CUMBERLAND COUNCIL DELEGATED PLANNING DECISION

1.	Reference No:	4/22/2477/DOC
2.	Proposed Development:	DISCHARGE OF CONDITIONS 3 AND 6 OF PLANNING APPLICATION 4/20/2048/0F1
3.	Location:	LAND ADJACENT TO ROCKSTONE RETREAT, INKERMANTERRACE, WHITEHAVEN

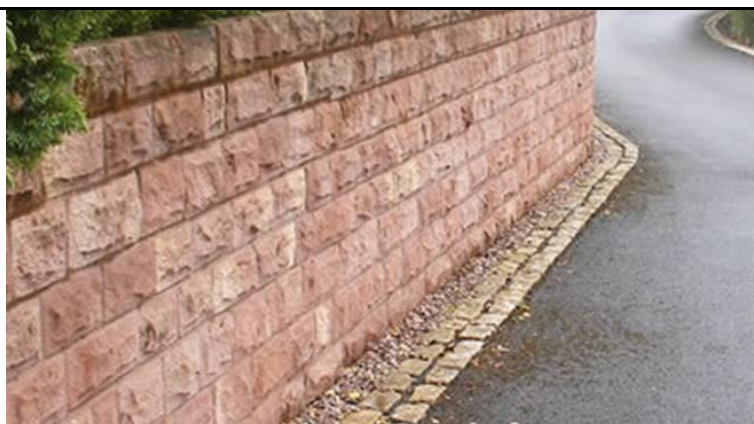
I think this might work, but am still a little unsure. There seem to be a couple of different copings shown but I'm not certain which will be used or whether either will match in with the existing ones.

The proposed masonry shown in the photos is known as coursed pitched face, with sawn edges, which will stand out in the context of the existing masonry. The existing is quite a rough, weathered rubble on the right side of the opening and a marginally more dressed but still pretty lumpy squared rubble on the left side.
